February 24, 2015

Subject: San Jacinto River Waste Pits Superfund Site - Significant Groundwater and Surface Water

Concerns

## Time Series of TEQ Concentrations in San Jacinto River at I-10

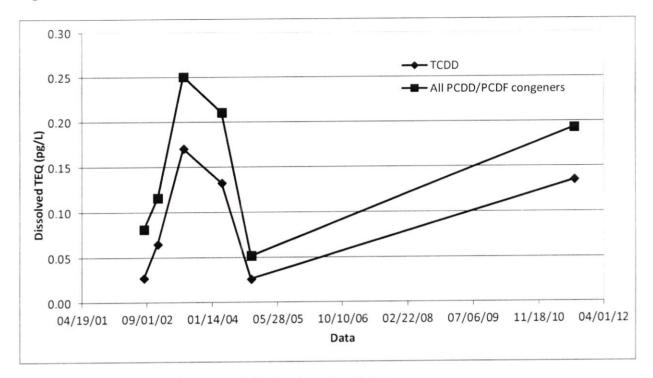
The latest dioxin data from surface water samples collected in the San Jacinto River at I-10 as part of the Houston Ship Channel dioxin TMDL project (August 2011 data provided by TCEQ) do not indicate that dioxin/furan concentrations in water adjacent to the Site are declining. There are no data to assess water concentrations after the cap was put in place, nor to determine the influence of groundwater contamination on the receiving surface water.
